**EPA Superfund
Explanation of Significant Difference
for the Record of Decision:**

**Marshall/Boulder Landfill,
Boulder County, CO
11/2/1992**

EXPLANATION OF SIGNIFICANT DIFFERENCES MARSHALL/BOULDER LANDFILL SUPERFUND SITE

November, 1992

EXHIBIT 1
WITH FINAL DESIGN REMEDY

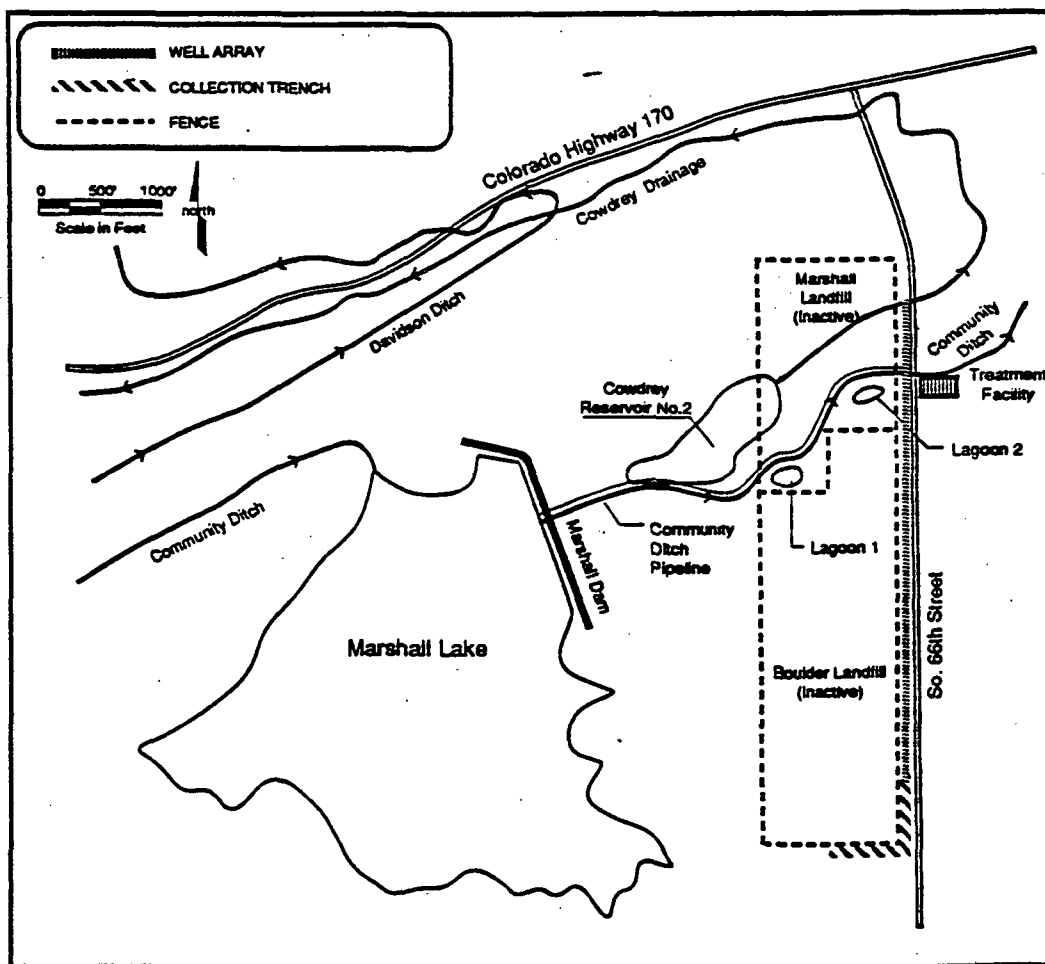
The 1986 ROD Remedy requires the collection of groundwater using a drain or series of drains along the southern and eastern Site boundaries. A collection trench as originally conceived is not feasible along the southern portion of the eastern boundary given the revised thickness and overall depth of the base of the saturated zone. A well array consisting of 30 extraction wells will replace the collection trench from a point approximately 600 feet north from the southeast corner of the Site to a point approximately 4,000 feet to the north, as shown in Exhibit 1. The well array will be designed to remove contaminated groundwater from the entire saturated thickness of the shallow aquifer in a more efficient and effective manner.

The groundwater collection system will not extend along the entire length of the southern and eastern Site boundaries, as called for in the ROD, for two reasons: 1) the alluvium near the southwestern and northeastern corners of the Site is apparently unsaturated and 2) existing piezometric data indicate that shallow groundwater along the western 700 feet of the southern Site boundary, if present, would migrate northward onto the Site. The intent of the 1986 remedy was to collect and treat groundwater leaving, rather than entering, the Site. The collection trench will be approximately 1,200 feet in length, beginning approximately 600 feet west of the southeastern corner of the Site and extending approximately 600 feet north to the well array, as shown in Exhibit 1. The western extent of the collection trench is midway between a well in which groundwater was encountered and a well in which groundwater was not encountered.

During the monitoring program, both water quality and piezometric data will be collected along the entire southern and eastern Site boundaries to confirm the presence of groundwater and the direction of groundwater flow. The collection system will be extended if shallow groundwater is detected in areas not included in the collection system. The revised configuration of the groundwater collection system is shown in Exhibit 1.

well array along most of the eastern Site boundary and a collection trench along part of the southern and eastern Site boundaries instead of only a series of drains as previously stipulated.

EXHIBIT 2
TREATMENT PROCESS FLOW DIAGRAM AS PER FINAL DESIGN

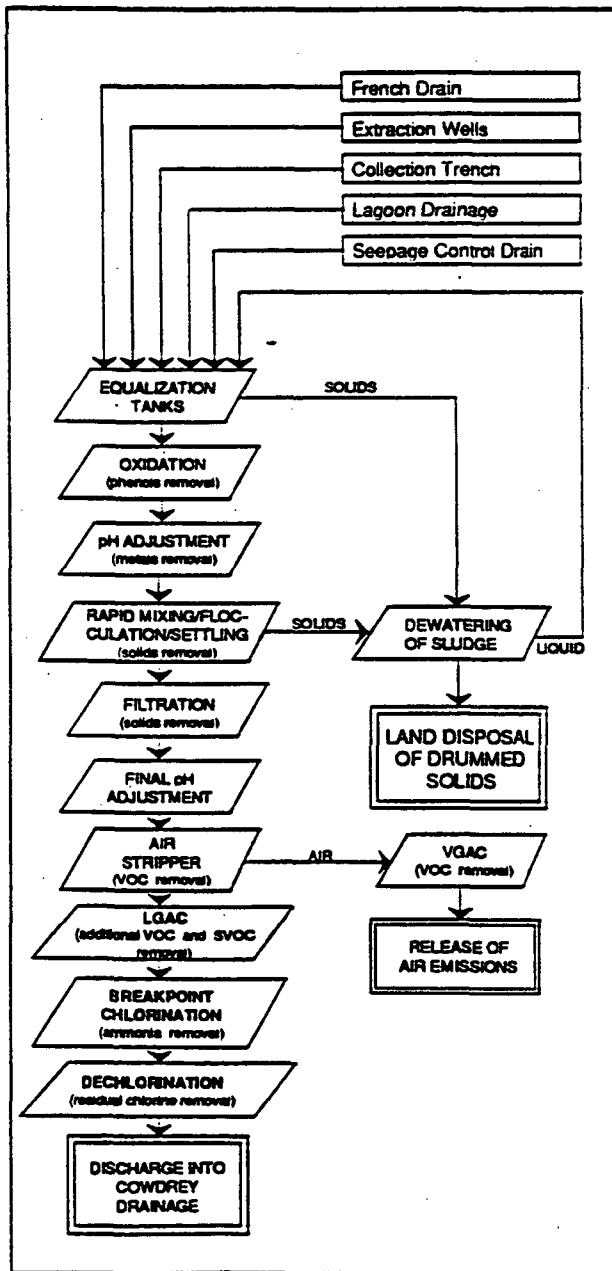
Breakpoint chlorination and dechlorination are being added to the treatment process to remove ammonia. During breakpoint chlorination, ammonia is oxidized to nitrogen gas by the addition of chlorine. Residual chlorine is then removed by adding sulfur dioxide. Dechlorination will be the final treatment step before discharge.

The 1986 ROD Remedy calls for the removal of VOCs with an air stripper and air stripper off-gas carbon adsorption. During remedial design, the Potentially Responsible Parties proposed adding an LGAC after they determined that discharge standards for VOCs

may not be consistently met. By passing the air stripper outflow through an LGAC, increased removal of VOCs and SVOCs would be achieved, assuring compliance with the discharge standards. Another benefit of the LGAC is its capacity to remove a wide range of organic compounds. Exhibit 2 shows the treatment process as revised by the modifications described in this ESD.

2. The collected groundwater will be treated to remove ammonia using breakpoint chlorination/dechlorination prior to discharge.
3. In addition to the air stripper and air stripper off-gas carbon adsorption system specified in the ROD, a liquid-phase carbon adsorption system (liquid-phase granular activated carbon, or LGAC) will be used to remove volatile organic compounds (VOCs).
4. The effluent limitation for chloride (measured as a 30-day average) will be 320 milligrams per liter (mg/l) rather than 280 mg/l.
